## Response to the consultation on TSRGD 2015 from CTC, the national cycling charity

### Current proposals in the draft TSRGD

Figure 5.1 proposed concept layout for a shared-use pedestrian/cyclist crossing

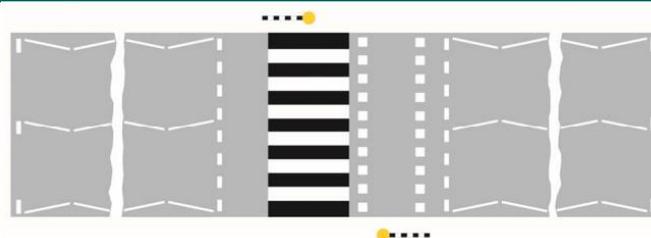
- 
- 2. Altering regulations and markings to permit pedestrian and cycle segregated zebra crossing** - until now cyclists have not been allowed to use zebra crossings, but, if implemented, the changes will mean cycle routes can be placed next to zebra crossings markings with drivers obliged to give way to cyclists when crossing. Priority crossings are absolutely vital to ensure any off-carriageway cycle tracks are safe and continuous. The anachronistic Belisha beacons and zig-zag lines will remain, however, which adds unnecessary street clutter (see below).

New regulations associated with the crossing will include the need to make drivers give way to cyclists, however, exactly when and how that priority will be ceded needs to be made completely clear, and accompanied by an advertised change in the law, together with a revision to the Highway Code.

We believe that the regulations must give local authorities the flexibility to include priority crossings for people on bikes which do not include the need for a negotiated priority. We understand that this represents a major change from present experience of zebras and will, as above, require changes to the Highway Code and advertising of the changes.

CTC also believes that local authorities be given the flexibility to dispense with Belisha beacons and zig-zag markings where these are deemed unnecessary by local risk assessment. Where speeds are low, for instance, and pedestrian traffic very important, there seems to be no reason why illuminated signs and zig-zags must be retained, particularly if street lighting is good enough. The requirement for zig-zags means that there are only a few cases (such as the incorrectly applied crossing shown below in Westminster) where local authorities are bold enough – or seek authorisation from DfT for – a crossing which is placed across the mouth of a junction.
